STP NUCLEAR OPERATING COMPANY  
Units 1 and 2  
Docket Nos. STN 50-498; STN 50-499  
Changes to Emergency Plan & Implementing Procedure

**Description of Changes**  
**0ERP01-ZV-IN05**  
**Site Evacuation, Rev. 6**

STI 31408066	<b>0ERP01-ZV-IN05</b>		<b>Rev. 6</b> General	Page 1 of 20
<b>Site Evacuation</b>				
Quality	Non Safety-Related	Usage: N/A	Effective Date: 03/13/02	
Max Keyes	N/A	N/A	Emergency Response Division	
PREPARER	TECHNICAL	USER	COGNIZANT ORGANIZATION

# PLAN A

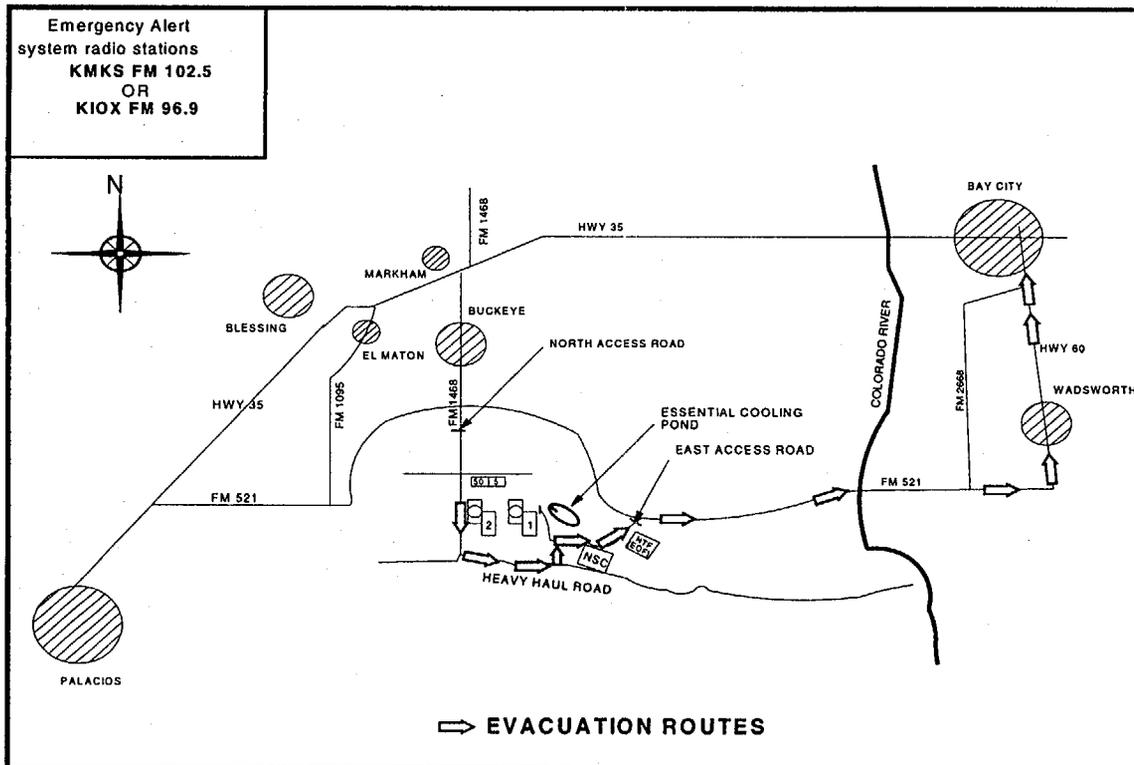
11.	Page 5, step 6.5, added "OPGP05-ZV-0004, Emergency Plan Implementing Procedure Users Guide."	Editorial "Reference"
12.	Addendum 1, page 6, added sector B, deleted the west access road gate, changed McAllister Junior High School to McAllister Middle School.	Changes due to closing the West Access Road and school name change.

**PLAN B**

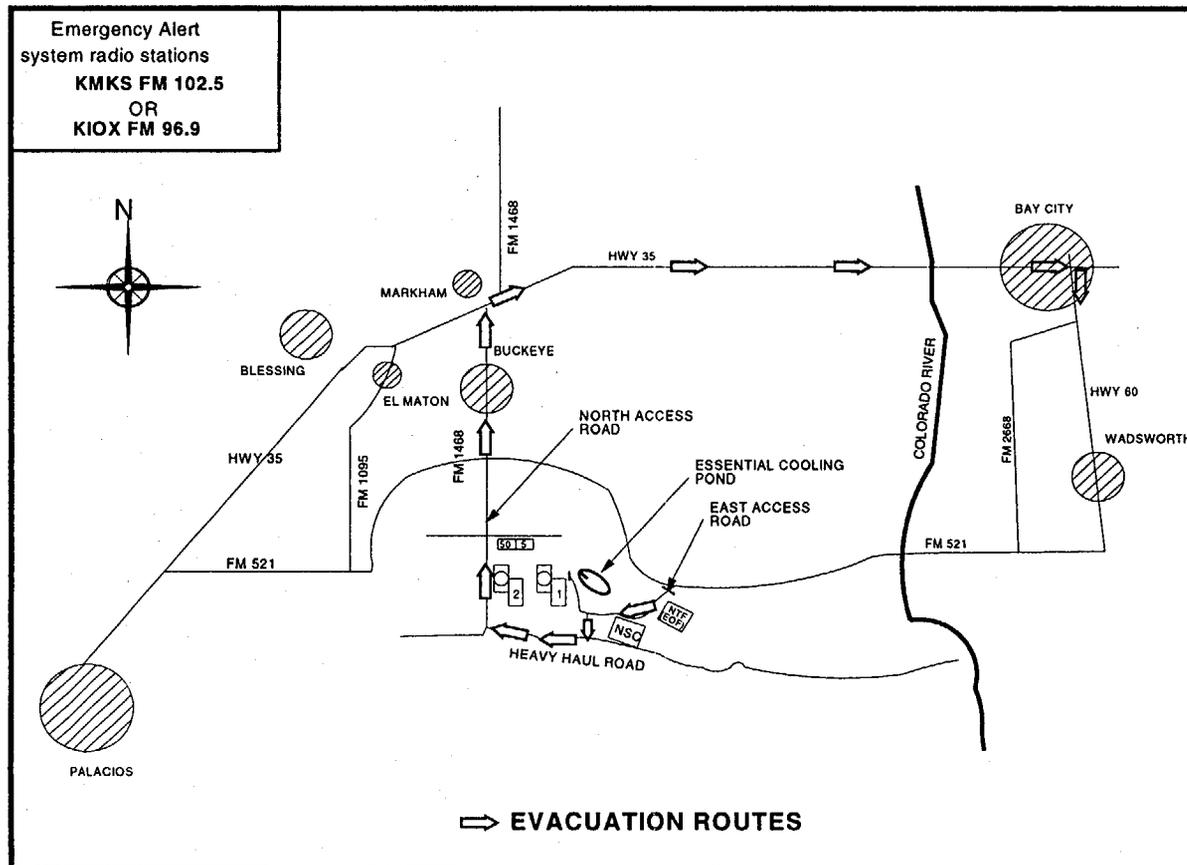
13.	Addendum 1, deleted old Plan B Map.	Changes due to closing the West Access Road.
14.	Addendum 1, page 7, changed from Plan C to B, deleted the west access road gate, changed McAllister Junior High School to McAllister Middle School.	Changes due to closing the West Access Road and school name change.

# PLAN C

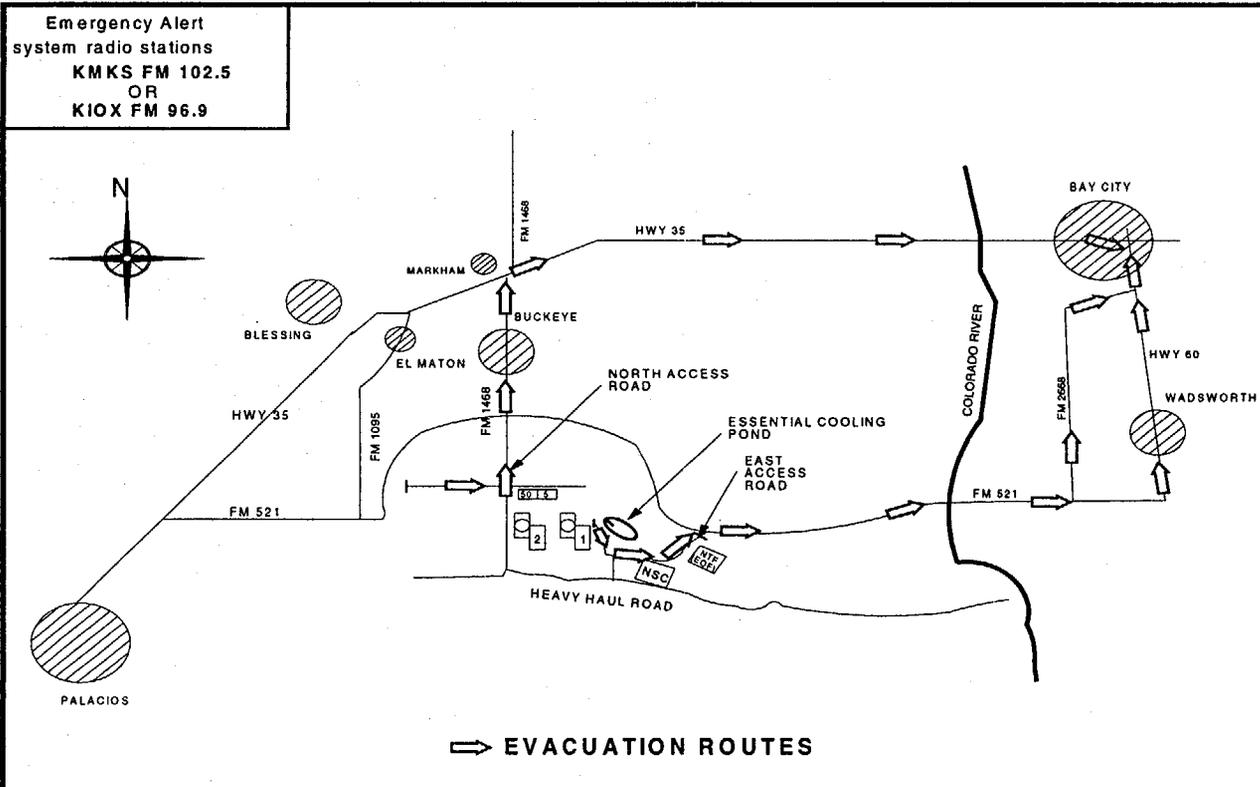
15.	Addendum 1, page 8, changed from Plan D to C, deleted the west access road gate, changed McAllister Junior High School to McAllister Middle School.	Changes due to closing the West Access Road and school name change.

# PLAN D

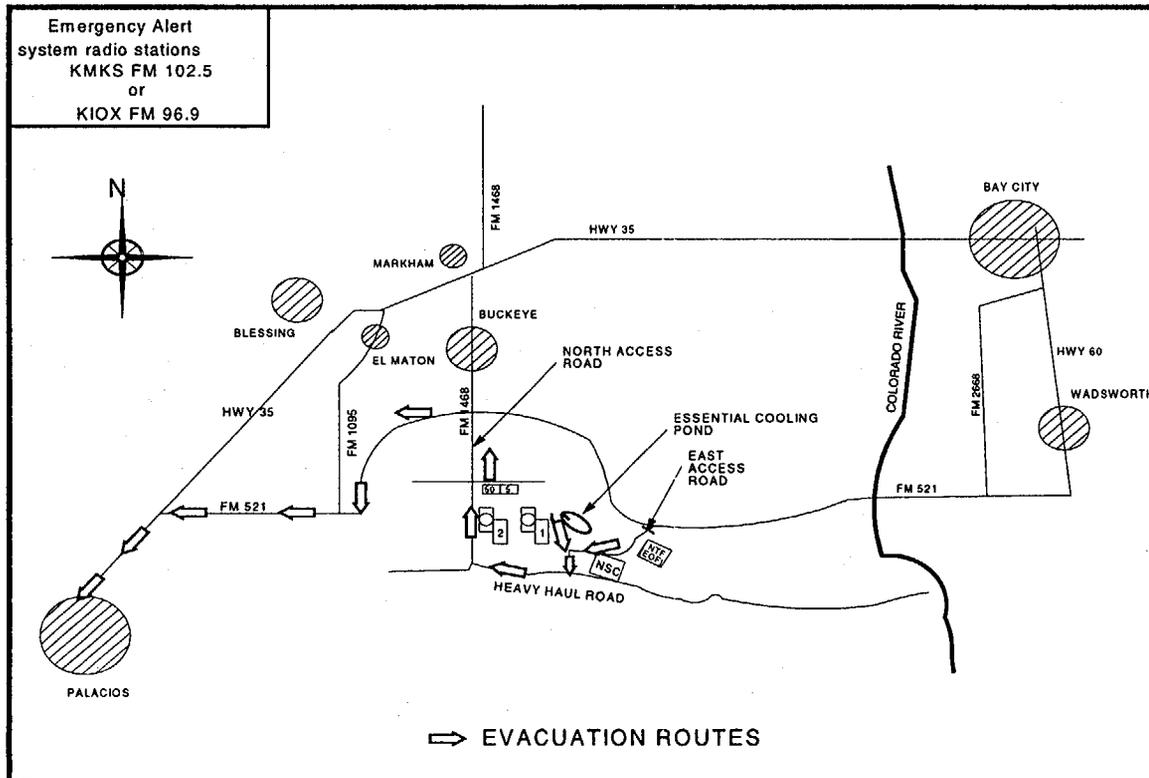
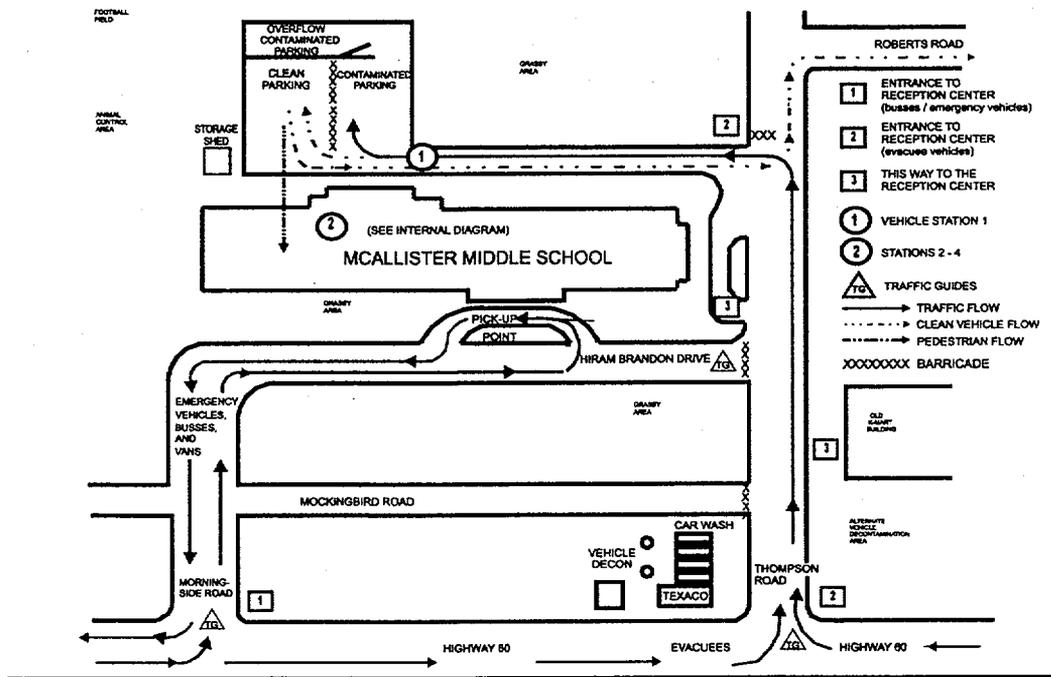
NO.	Change to Revision 5	Reason
16.	Addendum 1, page 9, changed from Plan E to D, deleted the west access road gate, diverted traffic from west to north access road, changed McAllister Junior High School to McAllister Middle School.	Changes due to closing the West Access Road and school name change.

MCALLISTER RECEPTION CENTER

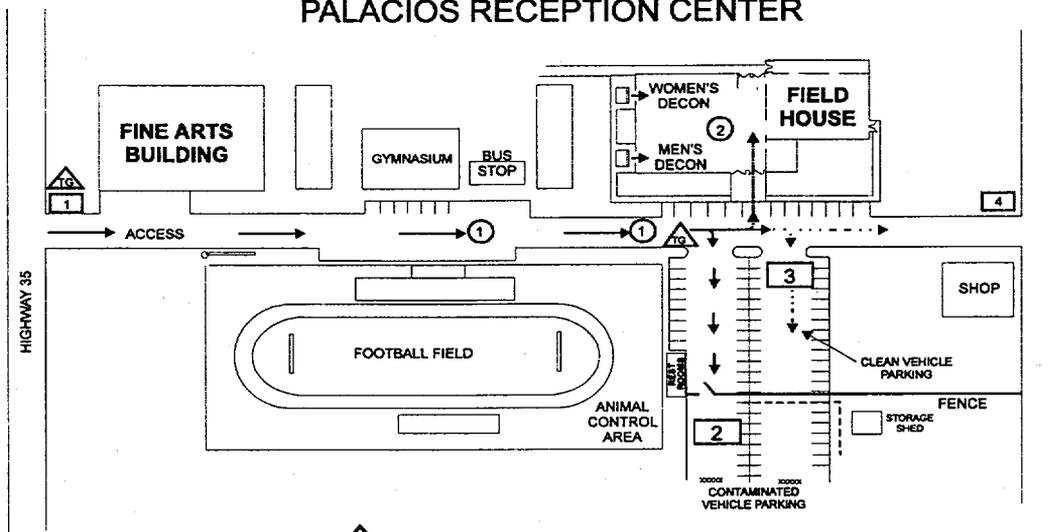
17.	Addendum 2, page 10, changed McAllister Junior High School to McAllister Middle School.	Name changed
18.	Data Sheet 1, page 11, changed from Assistant TSC Manager to Shift Supervisor.	Clarification, gives the SS specific direction and a checklist. The Assistant TSC Manager is directed to use Data Sheet 2.
